GENERAL MOTORS
DCS7112
URGENT - DISTRIBUTE IMMEDIATELY

Subject: N242485780 - Service Update
Power Steering Pump – Inspection Procedure

Models: 2024-2025 Chevrolet Express
2025 Chevrolet Silverado 2500 HD/3500 HD
2024-2025 GMC Savana
2025 GMC Sierra 2500 HD/3500 HD

N242485780 Power Steering Pump

6815800

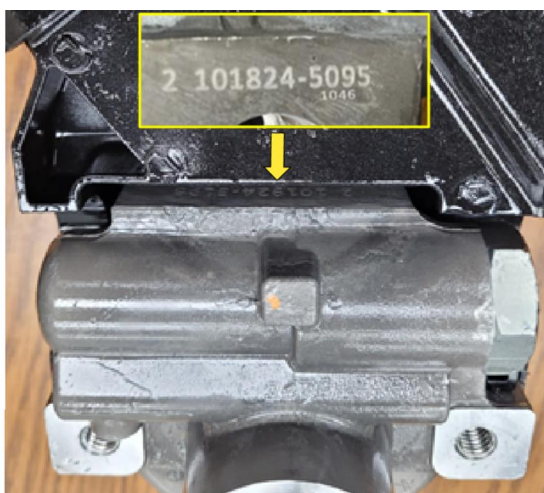
2. Insert a right-angle borescope behind the power steering pump pulley, from the most accessible side horizontally along the top edge of the Power Steering Pump. The date code and lot code are located on a flat between the reservoir and pump body as pictured below. Angle the camera towards the engine, as the codes are inside of the gap beneath the reservoir.

3. Verify the Date Code Range (6 digit) does not fall between 100424 and 102624.
 - If the code **IS NOT** between 100424 and 102624, the power steering pump is within specification and no further action is required.

- If the code **IS** between 100424 and 102624, proceed to step 4.
4. Verify the Lot Code Range (4 digit) is not within the 5000 series, seen as 5xxx.
 - If the code **IS** within the 5xxx Lot Code Range, the Power Steering Pump has failed inspection. Remedy parts are not available and the field action cannot be closed at this time.
